**REPORT
OF
STANDARDS AND NOMENCLATURE COMMITTEE**

May, 1924.

FIG. A

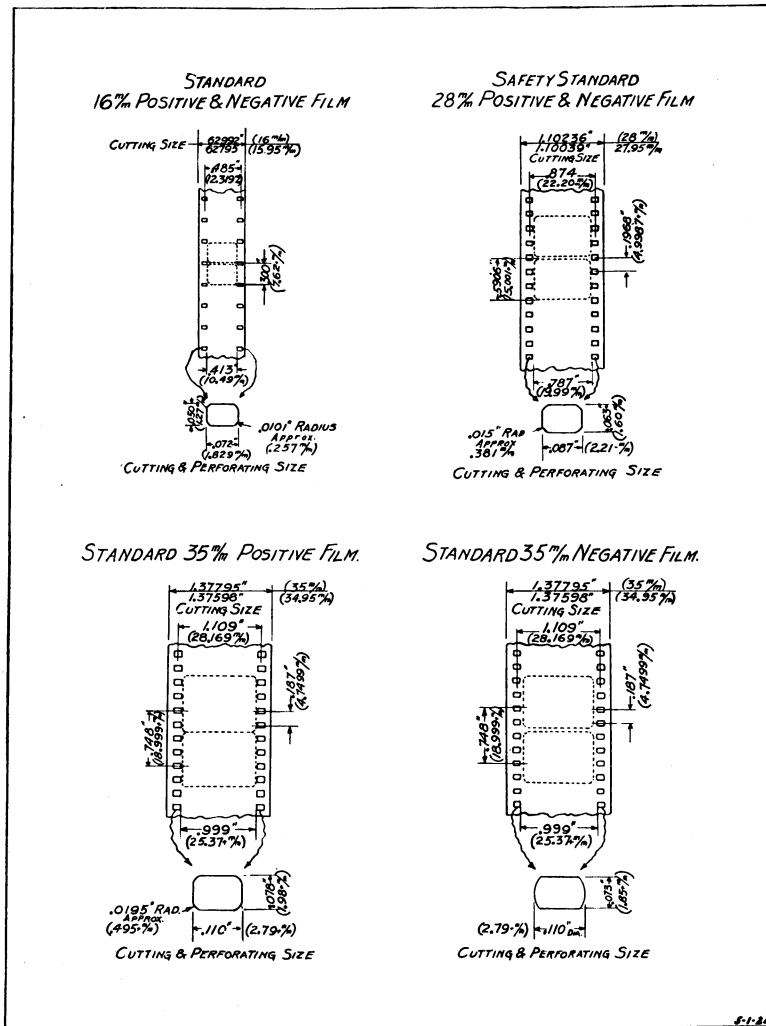
You will note (Fig. A) that in the case of the 35 m.m. film, we are recommending two standards; one for negative film and one for positive film. This is for the reason that we are recommending the use of rounded corners in the perforations of positive film. The need for perforating positive film with rounded corners has been apparent for a considerable length of time. The steadily increasing speed at which the films are run has made this demand even more urgent. Exhaustive tests have been made which show conclusively that the running life of the film is materially increased by the use of round corners in the perforations.

There is no difficulty experienced in printing on positive film perforated in this manner from negative film with flat side, round end style, or Bell & Howell standard perforations.

The increase in width of the perforation in 35 m.m. film from .073" to .078", has been found necessary to accommodate the varying sizes and designs of sprockets, thus considerably reducing interference, especially with shrunken films.

In connection with the cutting width, you will note that the tolerance for the minimum dimension for all sizes is .05 m.m. below the basic sizes, so that the cutting width will be nothing over and nothing under these limits.

DR. GAGE: I merely wanted to inquire whether the dimension for 35 m.m. 1.3779" was the maximum for tolerance limits.

MR. RICHARDSON: One of the principal points discussed by the Committee, the one that brought up the discussion, was the radius of the corner (indicating).

MR. CHANIER: I want to call your attention to the fact that the flat part is only .071; in the Bell & Howell it is .08228 and I think there is more chance of interference by the sprocket teeth in this perforation than in the other. I think we should have round corners but the flat part the same as on the Bell & Howell.

MR. BRIEFER: The proposed type of perforation appears logical because it has no corner, but I think the Society should not definitely commit itself on this type of perforation. Some experiments with which I am familiar, cast a shadow of doubt as to its thorough effectiveness. This may be the best perforation we can get, but I think we should go a little slow and recommend it only provisionally. If it is found after two or three other meetings of the Society that it has proven itself, it would be well then, to make it a recommendation of the Society. There is no doubt that this design looks better than the Bell & Howell standard, but, with the present type of sprocket tooth, it does not appear as having greater strength. I have not had sufficient experience with this proposed type to know whether it is the better perforation but, I am sure we should not commit ourselves on the proposition until it has proved itself worthy.

MR. VINTEN: I am going to read a paper dealing with this from the English Standards Committee. They take the biggest exception in this matter to the increased width. I believe it was arranged to engage six teeth or more and allow for the shrinkage. We felt that the alterations should be made to the sprocket teeth of the machine because I believe your researches showed there is a large variation in projectors and the standardization should be taken up at this end and not the standard film altered. They also consider that the corner is beneficial but should not take up more of the face than the Bell & Howell. They want to know whether the sprocket has to be rounded to take that radius of the corner where the film shrinks. They think it is a step in the wrong direction to increase

MR. CHANIER: I want to mention that the cutting width of the film has been changed from 1.375 to 1.3779. The former is the standard all over the world. I have a publication here giving the standard in England, France, Germany and the U. S. as 34.92 m.m. or 1.375". The American dimensions are taken from the S. M. P. E. standards adopted in 1917.

MR. CHANIER: The same thing comes in as in the positive—the cutting width.

MR. VINTEN: The English Society gives a tolerance on these limits and in connection with the negative there is 35 m.m. width with a plus limit and the positive only a minus limit.

MR. JOHN JONES: That shown is the intended tolerance for 35 m.m. size. You must have some tolerance on freshly cut film.

MR. JOHN JONES: That may vary, but it must not interfere where the sprocket engages. This radius (indicating) must not interfere. You see the specifications, 19/1000ths approximately, indicate it can be a trifle more or less. We found this radius would be about right.

MR. JOHN JONES: We could not do that very well.

MR. JOHN JONES: Then you reduce the edge margin.

MR. JOHN JONES: You say all over the whole world; in what proportion? For about seventeen years all the 35 m.m. film the Eastman Kodak Company has sent out has been cut to these dimensions.

PRESIDENT JONES: I think those suggestions can be given directly to the Standards Committee. The motion, then, as amended will be put. (Motion duly passed).

(Motion duly passed.)

Plate No. 1

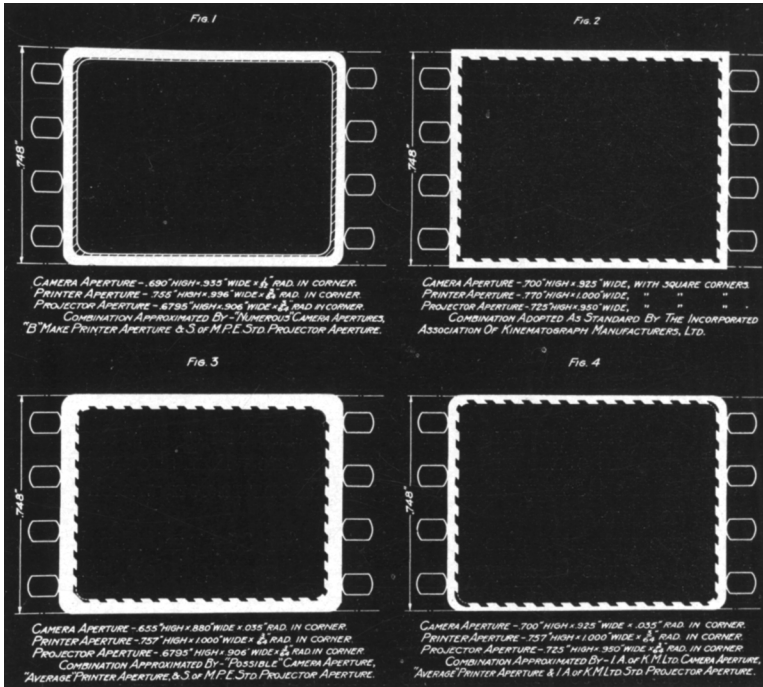
Shows the size of three different apertures super-imposed. The dimension .748" is equal to four pitches of standard film perforations. The single line cross hatch shows the size of aperture in "B" make of

camera as the negative would appear. The double cross hatch section shows the size of "B" make printer, this includes the black border which shows the amount the printer aperture overlaps the camera aperture. The clear outline shows the size of the "C" make projector aperture, the size of this being .6776" high by .908" wide with a corner radius of $1/16''$.

You will note that with a condition of this kind, it would not be possible to have the aperture of the projector large enough to allow the black border.

The black outlines show the "B" make printer aperture size; the cross hatch section shows the "A" camera aperture size; and the clear outline shows the "C" make projector aperture size.

In this case the positive film would have a black border but would be considerably larger than the projector aperture.

You will note the size of the "C" make camera aperture and "B" make printer aperture are the same length and very little difference in height, the height of the camera aperture being somewhat greater than the printer aperture.

In this case you will see there is no black border on the positive film.

The black border shows the outline of the "B" make printer aperture. The cross hatch area shows the size of the "A" make camera aperture, and the clear line area shows the "D" make projector aperture.

You will note that all of the projector apertures are approximately the same size.

Plate No 2.

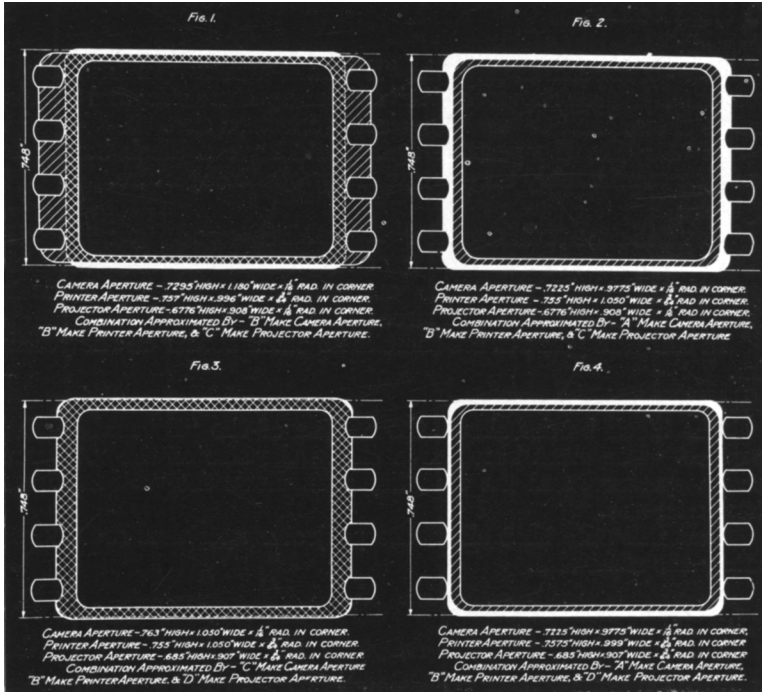
The black border outline shows the "B" make printer aperture; the cross hatch section shows the outline dimension of a great many makes of cameras; while the clear line area shows the projector aperture size as adopted by the Society. This is practically the prevailing condition at present.

Shows the size of camera, printer and projector apertures as adopted by The Incorporated Association of Kinematograph Manufacturers, Ltd. The continuous black border shows the size of the printer aperture; the extreme limits of clear area show the size of the projector aperture; while the area included within the black projection shows the camera aperture; thus giving a black border projected which would be about .012" margin between the camera and projector apertures. The total width of the black border, of course, would be the difference between the camera and printer apertures. You will also note in this case that the camera aperture's size, or size

of picture that would be projected, is somewhat larger than the aperture of the projector compared in the previous cases.

Shows a combination of aperture sizes that do not exist at the present time, but is shown as an example of what could be done by making the camera apertures smaller. The projector aperture in this case carrying the dimensions adopted by this Society, and the

printer aperture represents the existing average conditions of all machines which we have been able to measure. In this case the size of the camera aperture as shown would be somewhat smaller than any of the existing projector apertures, so that the outside dimensions of the picture on the screen would be smaller by approximately 3 to 4½ per cent, or a reduction in screen area of about 6 to 7½ per cent.

It would hardly seem proper to make any modification that would reduce the size of the picture on the screen.

The dimension of the outline black border is the same as in Fig. 3. The dimensions of the extreme clear area would be the size

of projector aperture which is somewhat larger than the dimensions standardized by this Society, being .045'' greater in height and .044'' greater in length. The dimensions of the area included between the projections would be that of the camera aperture and would be the same as shown in Fig. 2 except with rounded corners.

This would mean that the size of all projector apertures and camera apertures would have to be modified. Some of the camera apertures would have to be made larger and some smaller in order to meet this condition. The projector apertures, as aforesaid, would all have to be made somewhat larger—(approximately .025'').

It would seem, therefore, if it is not desirable to adopt the principle of the black border, that the dimensions as shown in Fig. 1, Plate 2, would be about the right size of camera and printing machine apertures to be adopted as standard. With this arrangement, any side weave of the film would not show the clear margin around the picture.

MR. McNABB: As long as the matter is being referred back to the Committee, one more point I think might be considered—if we can have the slide, I will show you. (slide projected.) The aperture could be extended to about here (indicating), with the purpose of having the margin of the frame come out into the white line of the perforation. This would facilitate assembly of positives, particularly in fade-outs and fade-ins, where the dividing line is difficult to see.
